Meeting Minutes Transmittal

GROUT TREATMENT FACILITY Unit Managers Meeting Ecology Office, Kennewick, Washington

ENGINEERING CHANGE NOTICES

REF DWG H-2-77639 SH 1

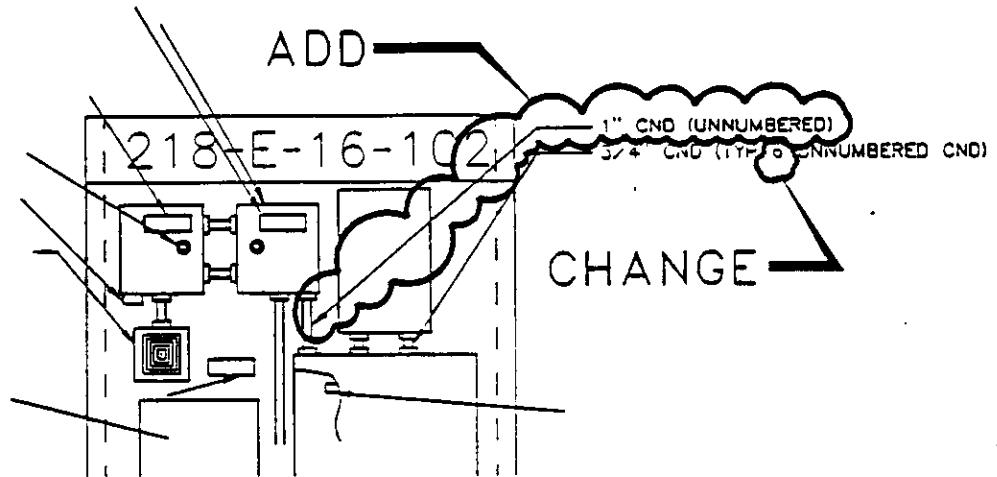
- 1) H-2-77639, Sh 1, Rev 2
Elevation J, Front View: Modify - see page 4 of this ECN.
- 2) H-2-77639, Sh 2, Rev 2
Elevation K, Front View: Modify - see page 4 of this ECN.
- 3) H-2-77640, Sh 1, Rev 1 (Affects ECN B-714-115, page 14)
Elevation Front View: Modify - see page 5 of this ECN.
- 4) H-2-78504, Sh 1, Rev 1
Change Note 17 to read as follows:

ECN No. B-714-166	Page 4/6
Rev. Orig. H-2-77645	Sh. 1 Rev. 2
Prep. By A R SNOWHITE	Ord. By G/H

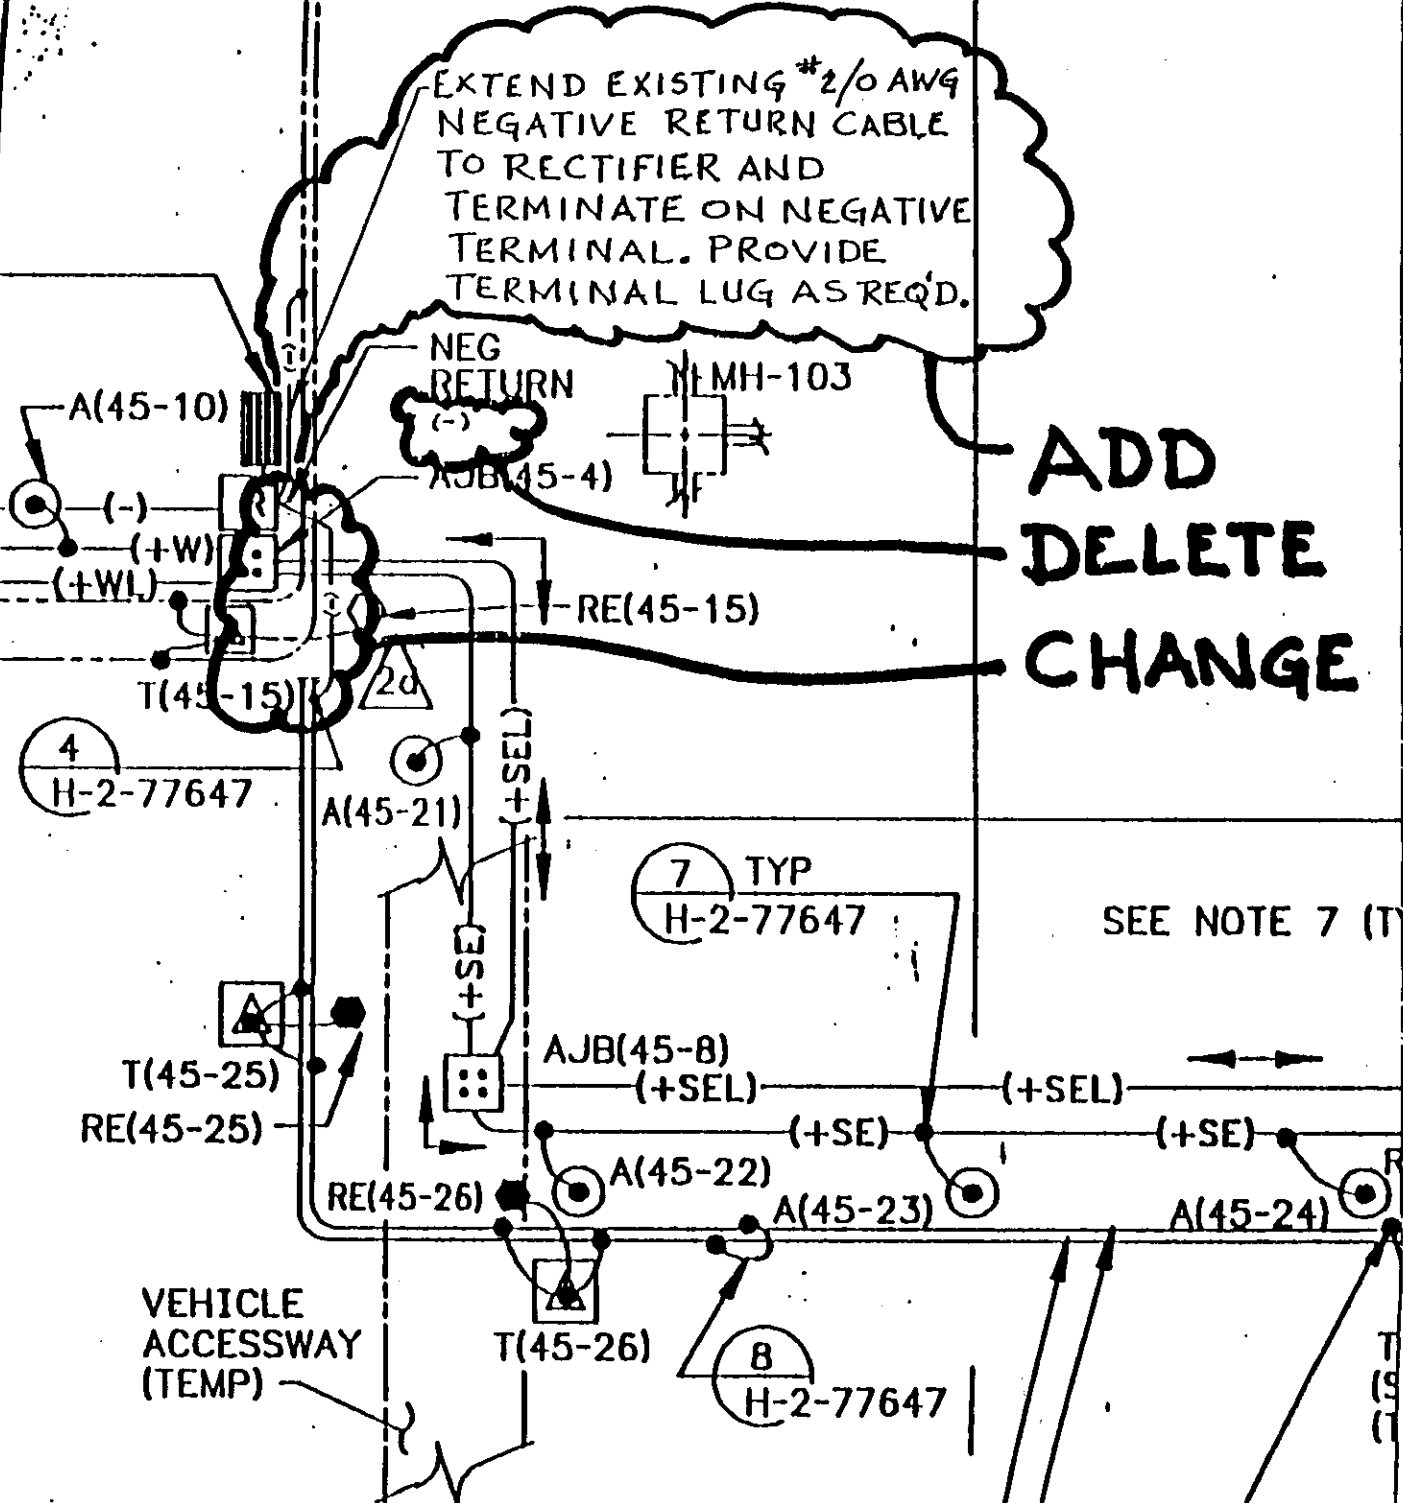
- A) Plan (Z D6): Modify - see page 4 of this ECN.
 B) Conn. Diag. (Z B5): Modify - see page 5 of this ECN.
 C) Test Sta. Table (Z A7); Change test station coordinates as follows:

(NOTE TO AS-BUILT: Pictorially relocate indicated test stations on the Plan (Z C4, C5, C6) to coordinates indicated above).

ANODE JUNCTION BOX
TYPICAL CONNECTION DIAGRAM
(SEE NOTE 1)

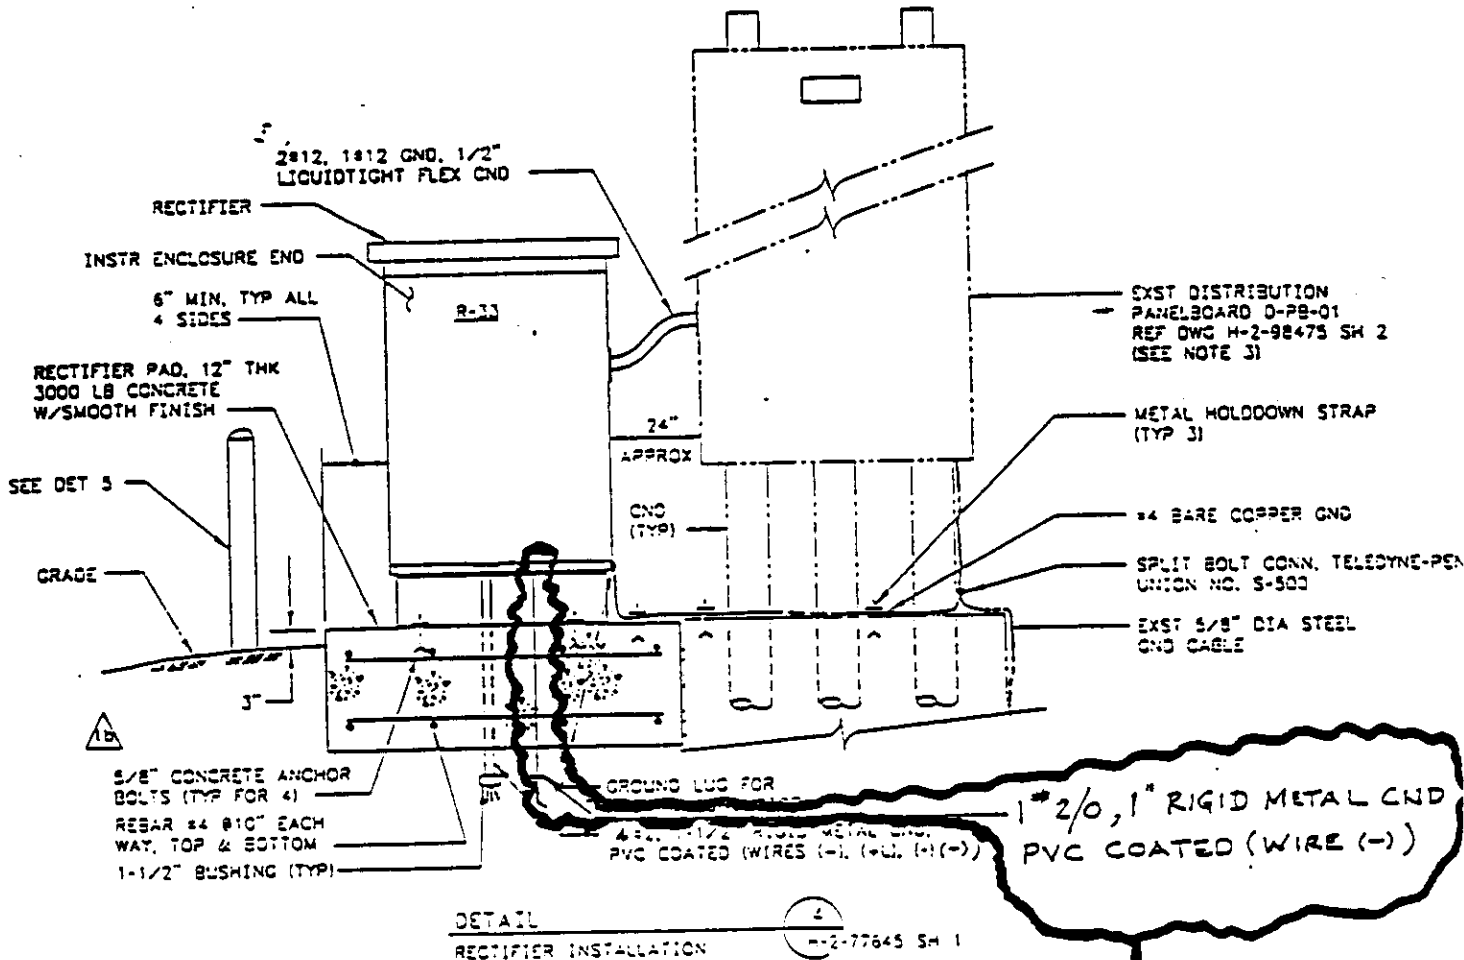
Detail 4 (Z A7): Modify - see page 6 of this ECN.
